File 1988-0045

Project Name: 621 26 1/2 Road - Rezone to PB and Outline Development Plan - Mercedes Cameron

FILE NO. 45-88 TITLE/HEADING Rezone to PB and ODP-Waller Prop. DUE DATE 11/16/88

PROJECT DESCRIPTION: A request to change from Residential Single Family (RSF-4) to Planned Business (PB45-88) and an outline development plan (ODP) for a clinic on approximately 3.88 acres.

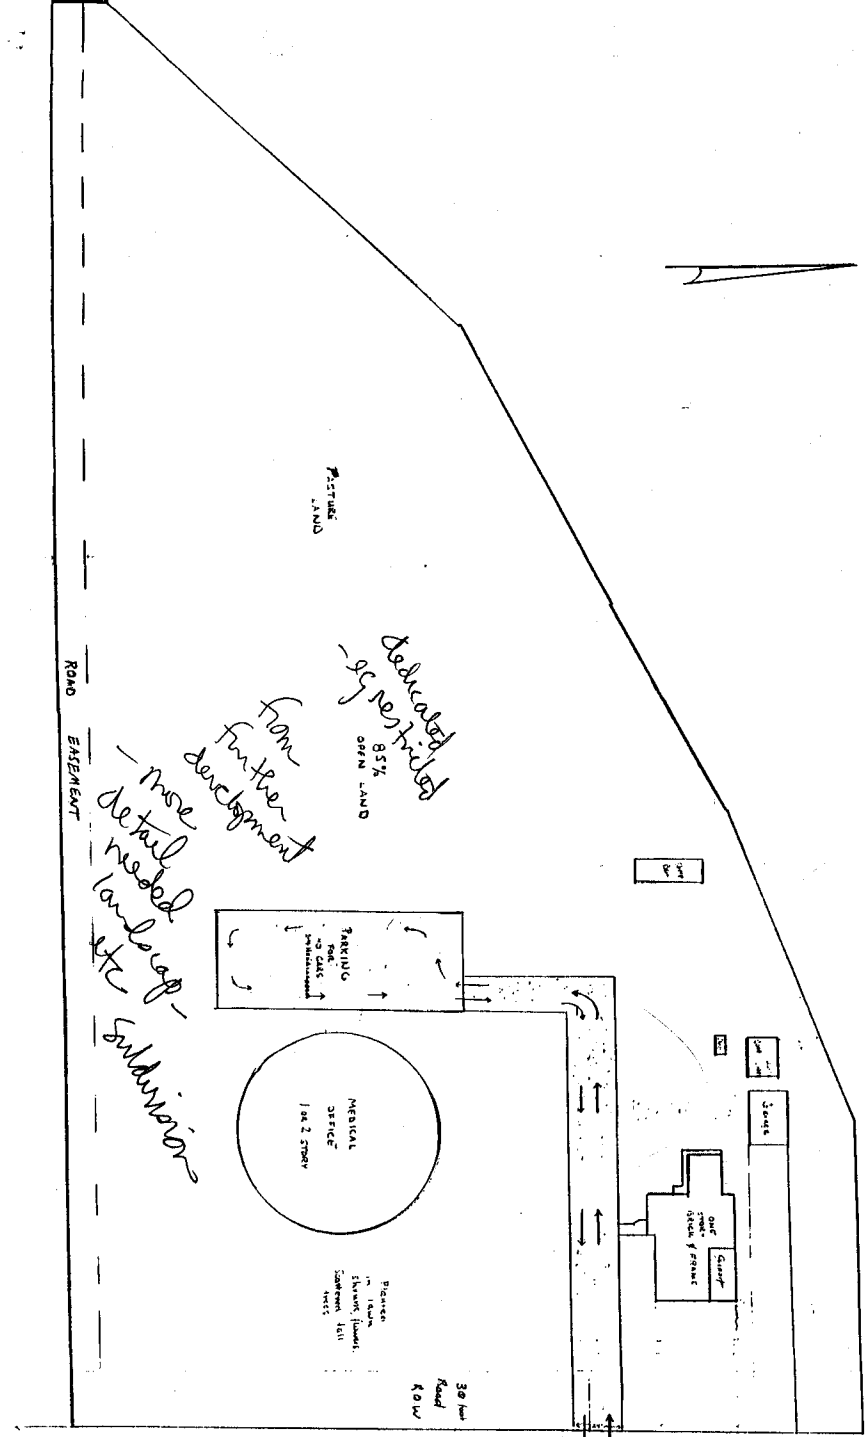
11/10/88	Police Dept.	No problems noted.
11/09/88	Fire Dept.	Our office hasn't any objection to this rezone. Before any building is to be done, we will need to review the plans to ensure compliance with the Uniform Fire Code.
11/02/88	City Attorney	<ol style="list-style-type: none"> <li>1. She is our family doctor.</li> <li>2. Master plan (corridor guidelines) compliance?</li> <li>3. Plat should reflect the restriction for further development, e.g. limit to "pasture" or other open space as shown.</li> <li>4. Before proceeding to prelim./final, will need more detail/plot plan, elevations, location of lighting, etc.</li> <li>5. Space for 40 cars seems to suggest a significant amount of traffic--high impact?</li> <li>6. Is a subdivision split contemplated between the office use and the residential home?</li> </ol>
11/09/88	County Planning	No comment.
11/10/88	Public Works	Review is difficult given lack of utilities composite and site drainage information. Would like to see alternative access connecting to Horizon Place to the north. Would like clarification of the intent of the "road easement" along the south edge of property. Is it existing or to be dedicated?

11/16/88	City Engineer	Future development of filing number four of Northridge Subdivision will require the extension of Horizon Place to the north side of the Ranchman's Ditch near the west end of the Waller property. This alignment will provide access to 7th Street through the signalized intersection at 7th Street and Horizon Place. This access should be included in the ultimate development plan for the Waller property. Detailed site, grading, drainage, and utility plans will be required prior to issuance of a building permit.
11/16/88	Planning Dept.	(see attached)

Site design details will be addressed at the preliminary plan and plat stage. We would like to see only one access onto 7th Street from the property. Traffic accessing directly onto 7th Street will be a consideration in determining the appropriate size of the facility. What are the intentions for the road easement along the south property line?

Public Works: Utilities composite and site drainage info, not required for O.D.P. Alternative access to Horizon Place is a moot issue at this time because of uncertain status of Northridge Filing 4. Road easement on south side is in process of being vacated.

City Engineer: Once again, access across Ranchman's Ditch to Horizon Place cannot be addressed in a definite sense at this time because of the uncertainty surrounding plans for Northridge and Mesa View.

Planning Department: We intend to have only one access onto 7th Street. The road easement along the south property line is being vacated.
